The Performance-based Operations Aviation Rulemaking Committee (PARC) Steering Group is pleased to submit the following recommendation from the PARC Navigation Working Group for your consideration: RF Construction on RNP APCH with Extended Visual Segment.

## RF Construction on RNP APCH with Extended Visual Segment – Problem Statement

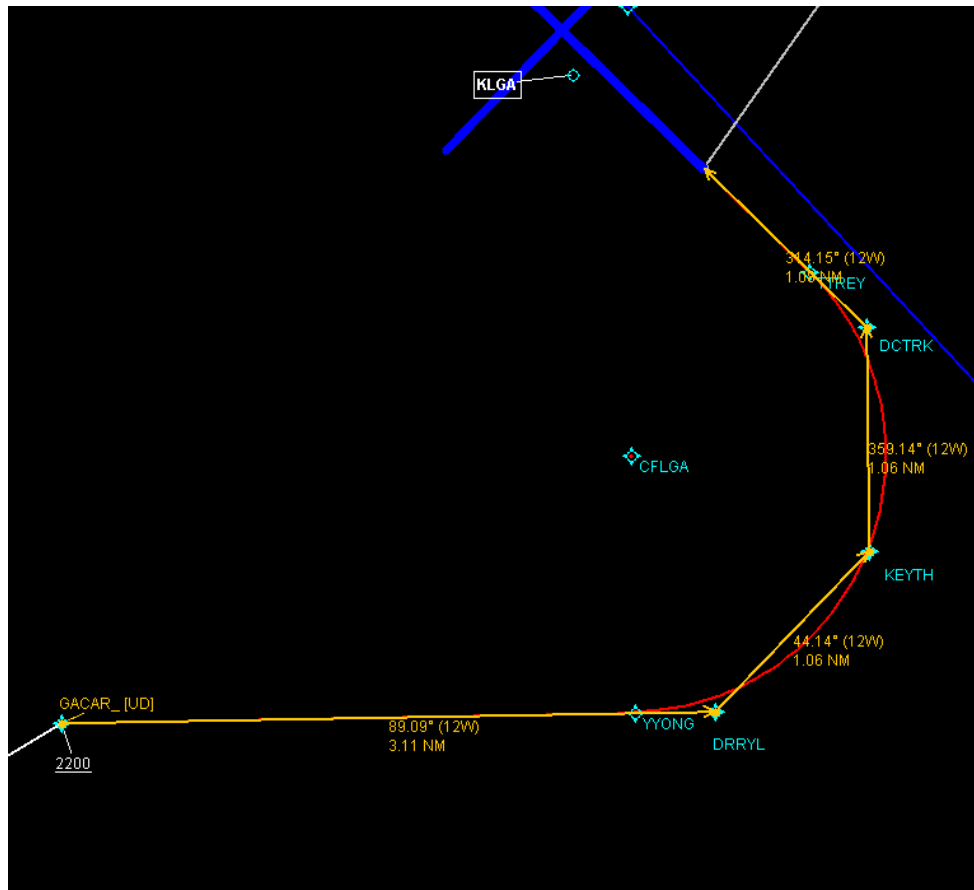
The image above shows how the KLG RNAV (GPS) X Rwy 31 had to be constructed to get an RF to fit the FAA constructed TF legs. The waypoint DRRYL is the MAP on the FAA version, but DRRYL is not on the RF version since if we waited until DRRYL to start the RF leg, the two procedures wouldn't overlay. This created a couple issues for the tailored RF version:

- 1) Different MAP waypoints on the RF and TF. Technically the extended visual segment is outside DRRYL and so tailoring should only take place after DRRYL. Adding RF cannot be done while keeping ground track compliance.
- 2) Different approach minima since the instrument approach ends at the MAP and the MAP for the RF had to be placed before the MAP on the public procedure.

Had the FAA been responsible to provide construction of the RF, the MAP could be the same with the same approach minima. DRRYL simply would have been an additional waypoint in the Extended Visual Segment after YYONG.
